Re: Emery Deep Mine Permit C/015/015
Amendment to MRP to revise partial pillar splitting plan

Title: Updated Pillar Split Plan

Update the MRP to match the MSHA approved Pillar Splitting Plan

**Figure 1: Partial Extraction with Timbers for Supplemental Support
Mirror image applies**

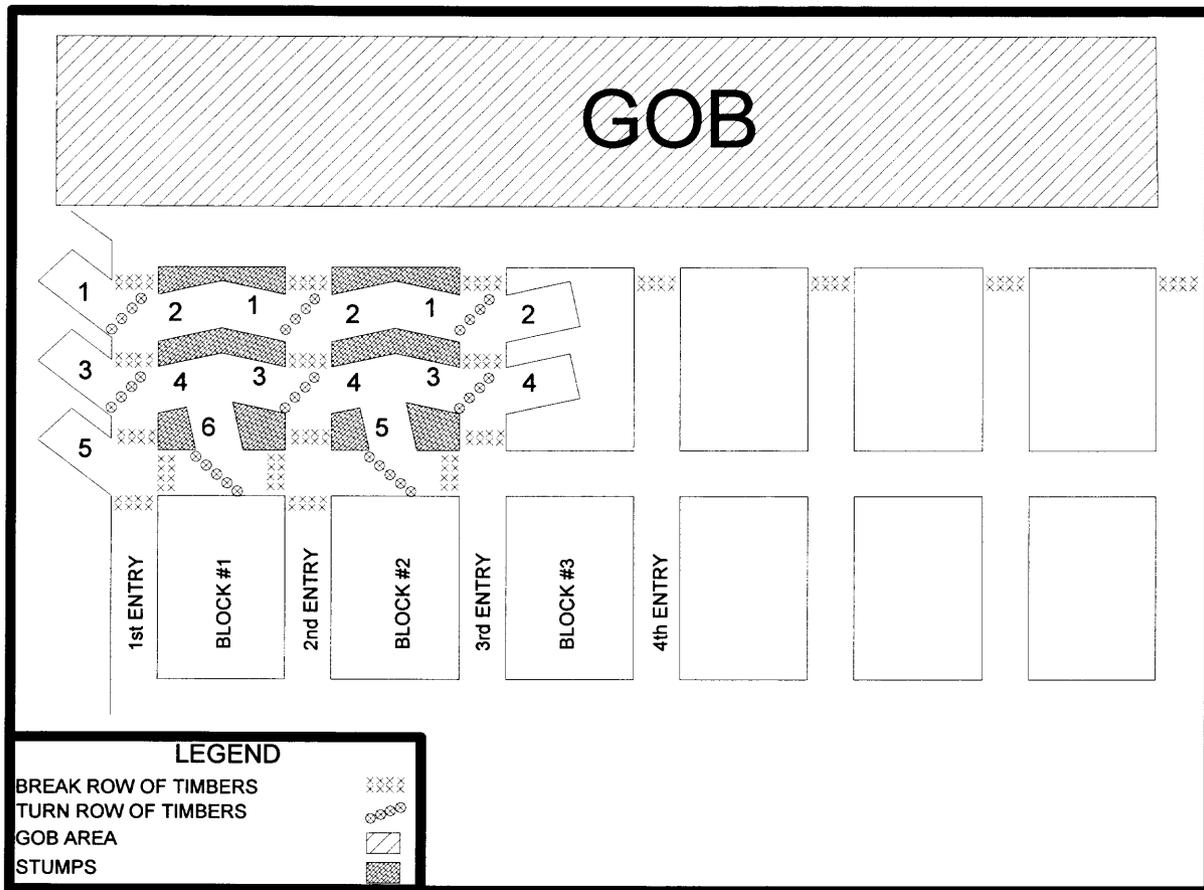
The mining method used is room and pillar with partial pillar removal. Full extraction mining is not practiced at Emery. As a result, any subsidence would fall into the unplanned category. Figure ~~1V-2~~ pg. 28 shows the partial pillar splitting diagram ~~range of pillar and room dimensions employed underground.~~ These layouts are the result of past experience as well as state and federal regulations pertaining to roof control and ventilation. ~~Roof spans are based on the same criteria. Roof spans are limited to 18 ft. except in second pass mining of pillars, in which case they can be as wide as 20 ft. Figures V-3 and V-4 show the second pass mining methods for partial pillaring during retreat from the section.~~ This methodology has been approved by MSHA.

**PILLAR SPLIT PLAN SITE SPECIFIC FOR
2ND SOUTH**
